CY7C129*DV18/CY7C130*DV25
 CY7C130*BV18/CY7C130*BV25/CY7C132*BV25
 CY7C131*BV18 / CY7C132*BV18/CY7C139*BV18
 CY7C191*BV18/CY7C141*AV18 / CY7C142*AV18/
 CY7C151*V18 /CY7C152*V18

Errata Revision: *C

RAM9 QDR-I/DDR-I/QDR-II/DDR- II Errata

Figure 1 shows the DOFF pin circuit with an internal 5K Ω internal resistor. The fix planned is to disable the internal 5K Ω leaker.

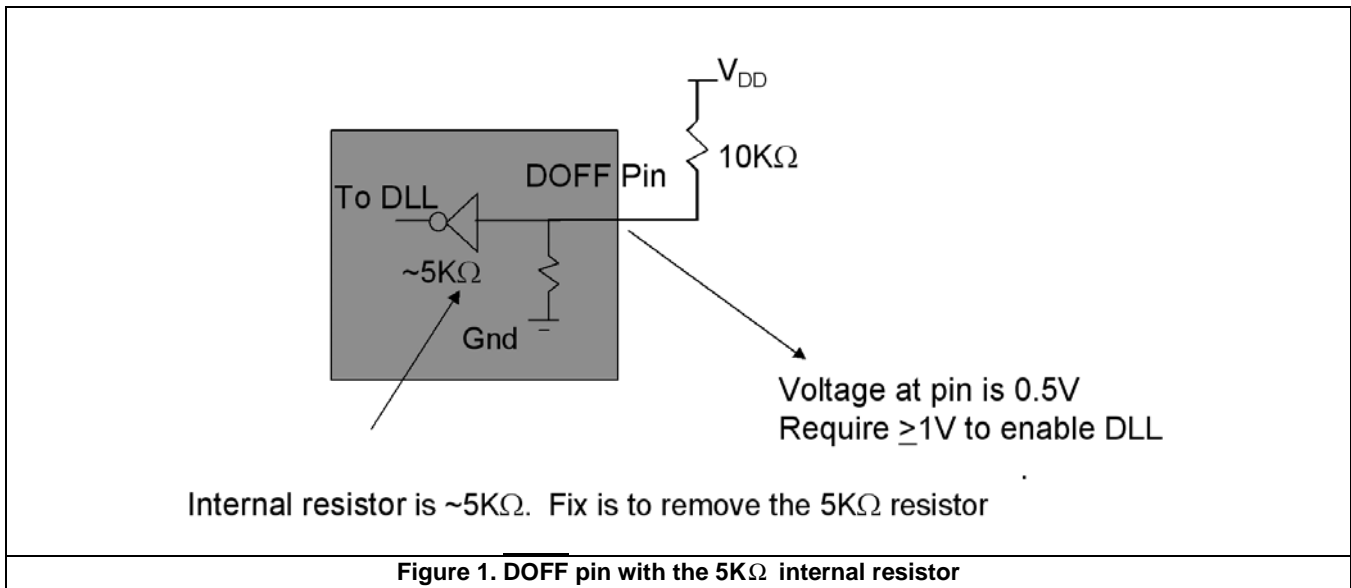
This issue involves the DLL not turning ON properly if a large resistor is used (eg:-10K Ω) as an external pullup resistor to enable the DLL. If a 10K Ω or higher pullup resistor is used externally, the voltage on DOFF is not high enough to enable the DLL.

Fix involved removing the internal pull-down resistor on the $\overline{\text{DOFF}}$ pin. The fix has been implemented on the new revision and is now available. The new revision is an increment of the existing revision. The following table lists the devices affected, current revision and the new revision after the fix.

Figure 2 shows the proposed workaround and the fix planned.

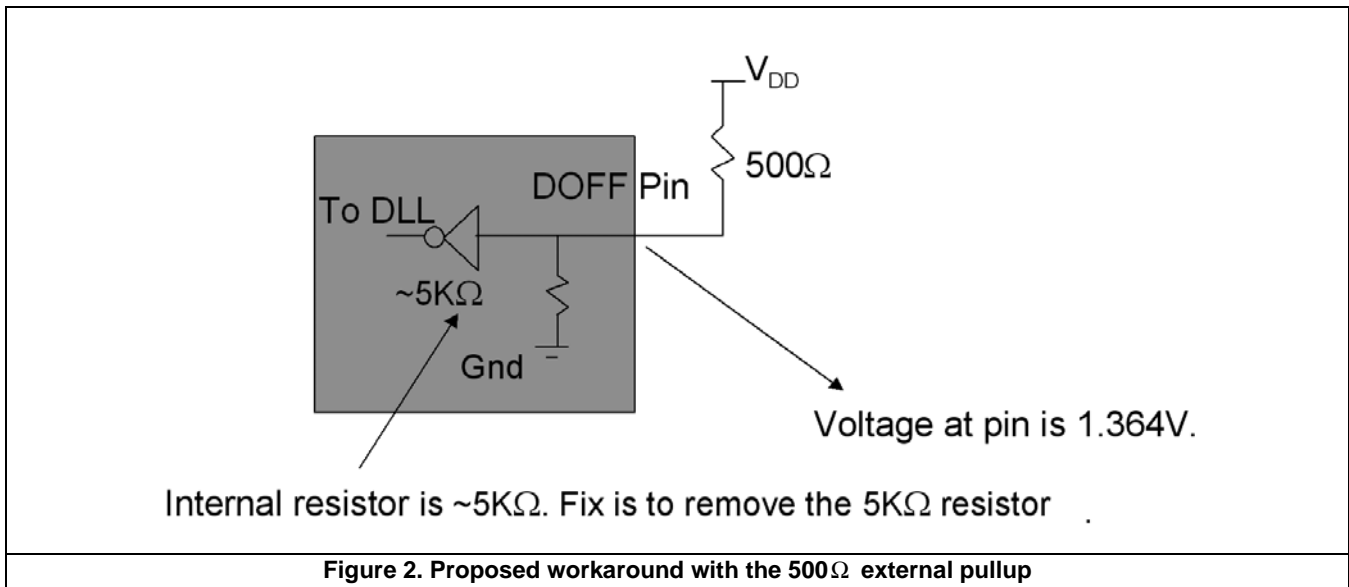
The workaround is to have a low value of external pullup resistor for the $\overline{\text{DOFF}}$ pin (recommended value is $\leq 500\Omega$). When $\overline{\text{DOFF}}$ pins from multiple QDR devices are connected through the same pull-up resistors on the board, it is recommended that this $\overline{\text{DOFF}}$ pin be directly connected to V_{DD} due to the lower effective resistance since the "leakers" are in parallel.

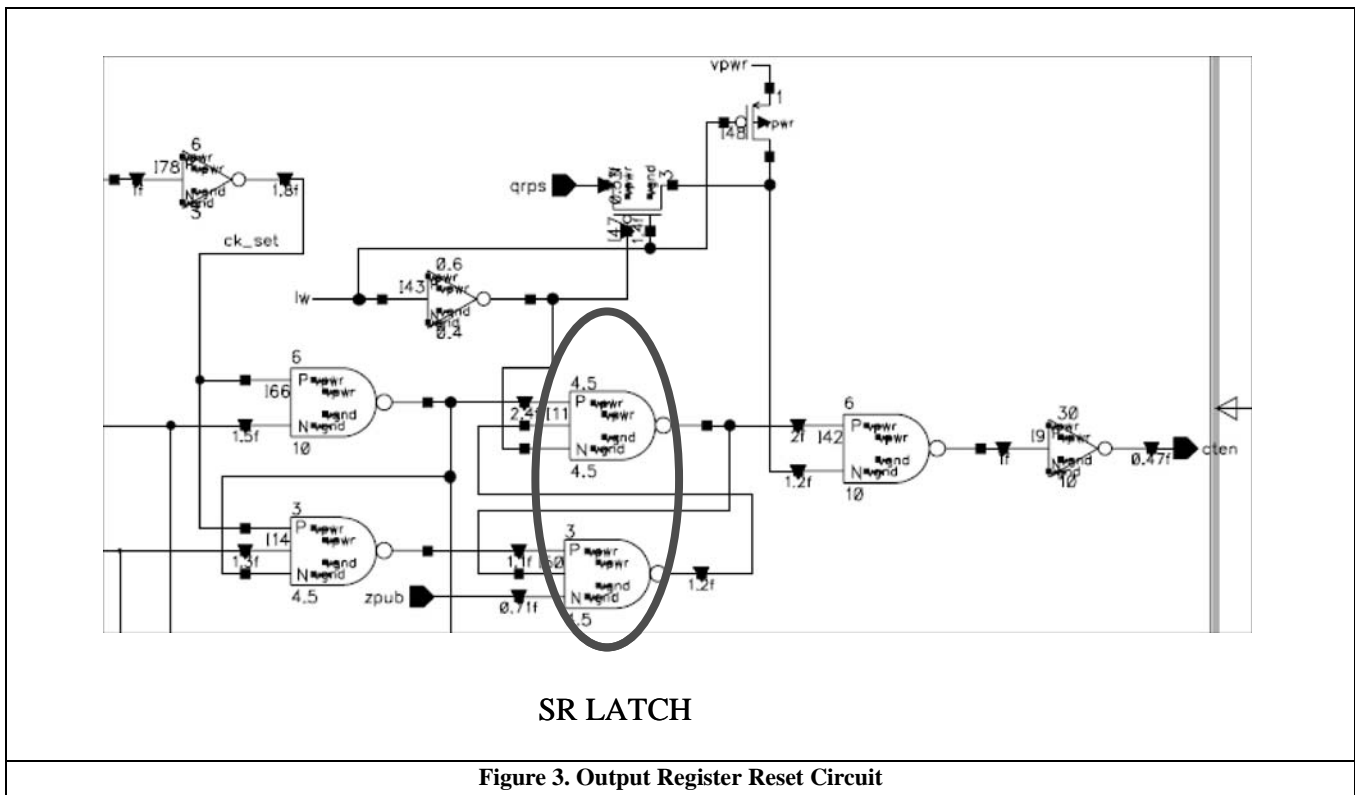
This issue involves the output buffer entering an unidentified state when the input signals (only Control signals or Clocks) are floating during reset or initialization of the memory controller after power up.

Figure 3 shows the output register Reset circuit with an SR Latch circled. This latch has two inputs with one of them coming from some logic affected by the clock and RPS#(QDR) or WE# and LD#(DDR). The issue happens when clocks are glitching/toggling with controls floating. This will cause the SR latch to be taken into an unidentified state. The SR Latch will need to be reset by a dummy read operation if this happens.

The fix has been implemented on the new revision and is now available. The new revision is an increment of the existing revision. Please refer to Table 4 for the list of devices affected, current revision and the new revision after the fix.

Figure 4. Dummy Read Implementation

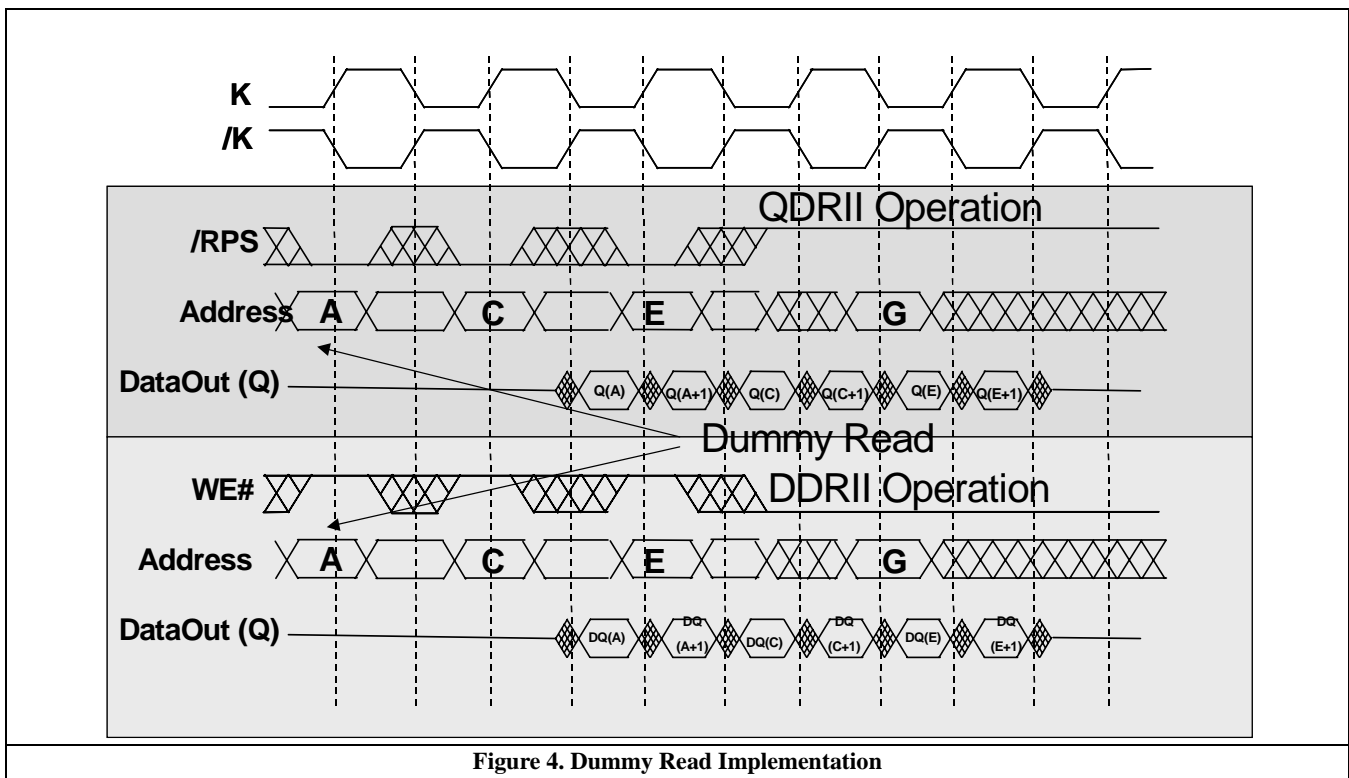
This is viable only if the customer has the trigger conditions met during reset or initialization of the memory controller after power up. In order for the workaround to perform properly, Cypress recommends the insertion of a minimum of 16 “dummy” READ operations to every SRAM device on the board prior to writing any meaningful data into the SRAM. After this one “dummy” READ operation, the device will perform properly. “Dummy” READ is defined as a read operation to the device that is not meant to retrieve required data. The “dummy” READ can be to any address location in the SRAM. Refer to Figure 4 for the dummy read implementation.
